4.0 REVIEW OF MONITORING WELLS SURROUNDING THE LANDFILL

Project Title
INDEPENDENT EXTERNAL REVIEW OF CRANE MOUNTAIN LANDFILL

Project No.	5668-001.1	
Dwg. No.	FIGURE 4-1	Rev. No. 0
Scale	1:5000

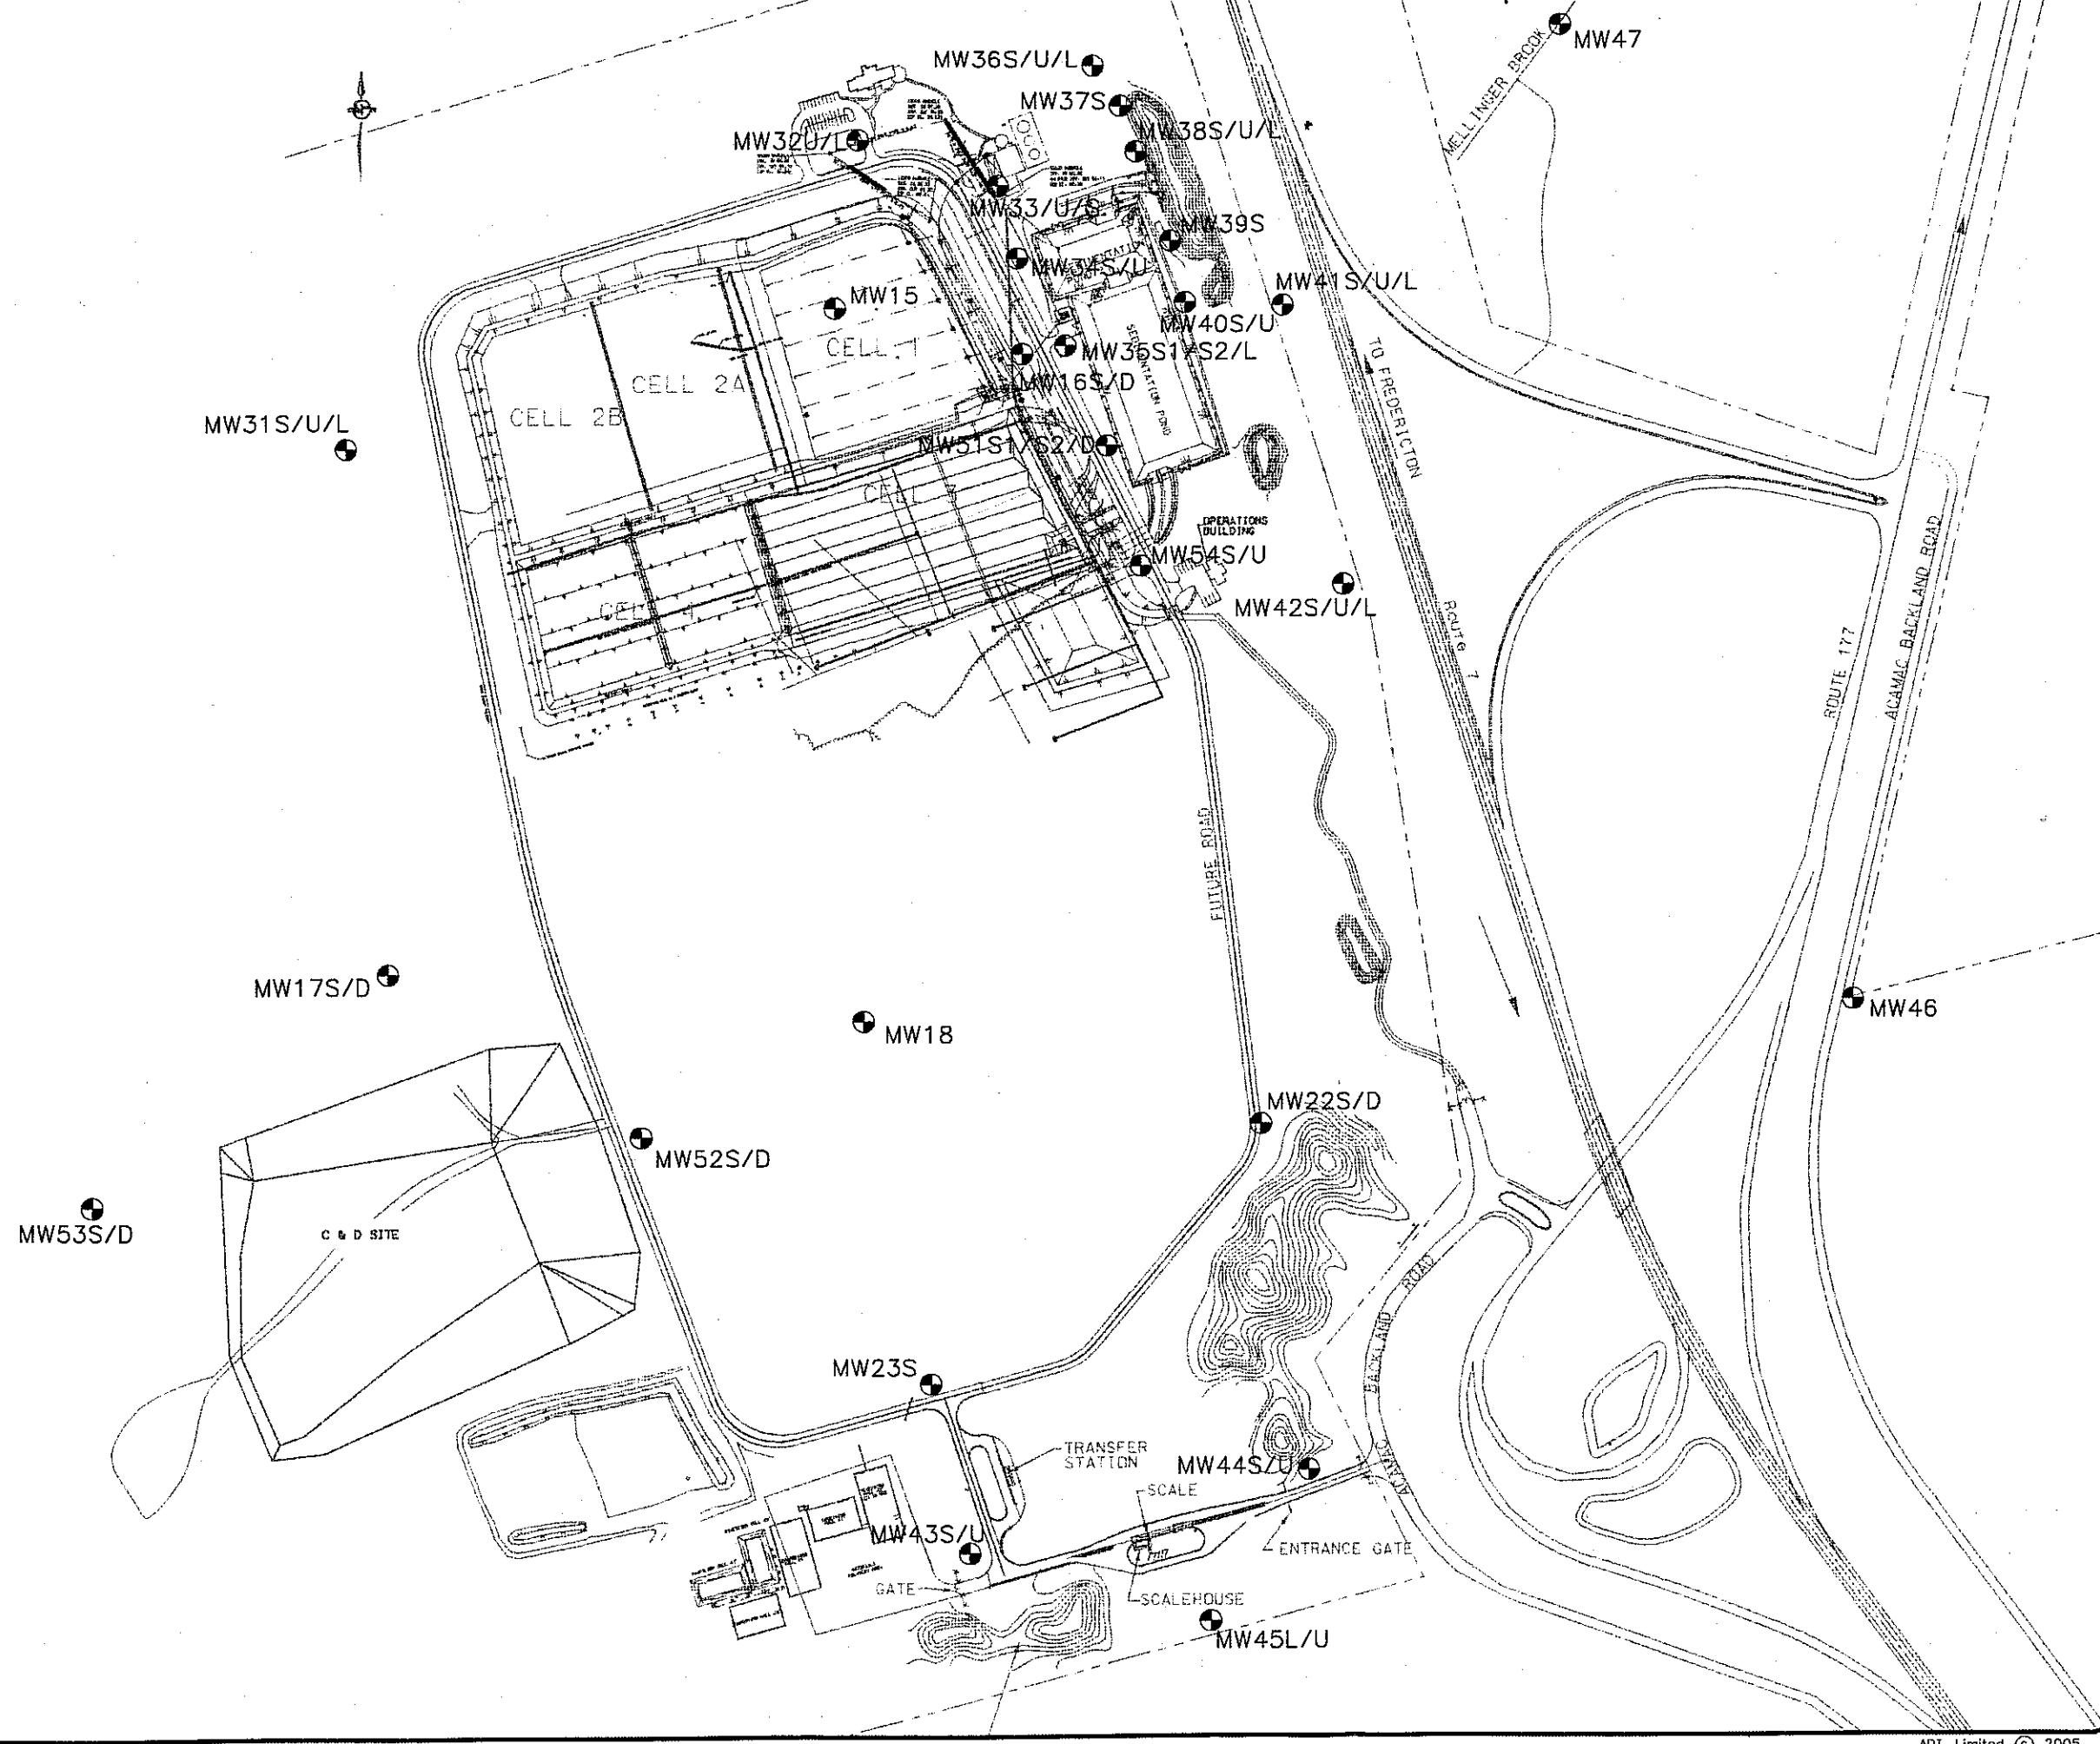
As discussed in **section 2.2** site stratigraphy includes a variable depth of overburden sediments (mainly glacial till) overlying fractured bedrock. Typically, monitoring well networks for solid waste disposal sites should include nested wells to monitor each distinct hydrostratigraphic unit (e.g. overburden deposits, shallow bedrock, “intermediate” bedrock, and “deeper” bedrock). The Crane Mountain monitoring network has generally been completed in this manner. Based on a review of the background information provided related to the site groundwater monitoring network, it appears that the existing network is similar to those installed at other regional landfill facilities in the province, and is considered adequate with respect to location, design and number of on-site monitoring wells given the hydrogeological characteristics of the site.

It is recommended that further characterization of the hydrogeological system be made as it relates to flow pathways within the bedrock and geochemical evolution of groundwater in the context of water supply usage by downgradient domestic wells.

Sample Monitoring Well Results
Figure 4-2

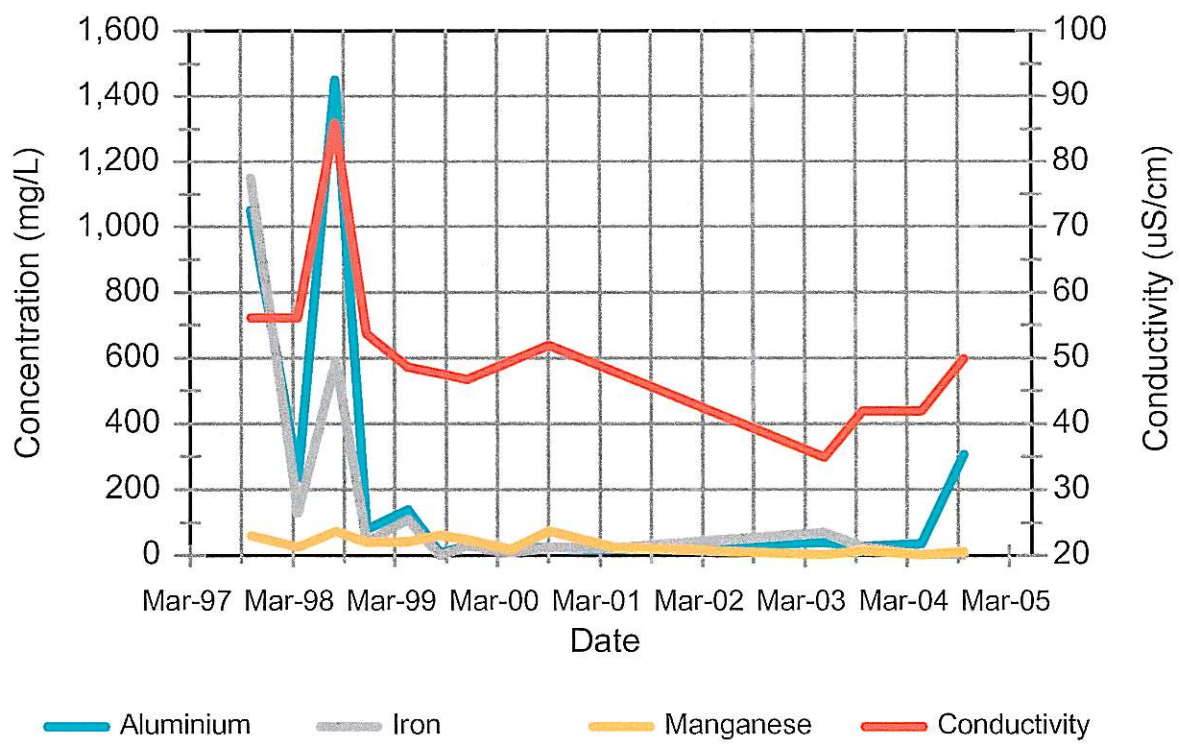
Some examples of analytical plots (trend plots) that would be useful in identifying analytical anomalies are shown in Figure 4-2. Such plots should be developed and maintained on an ongoing basis.
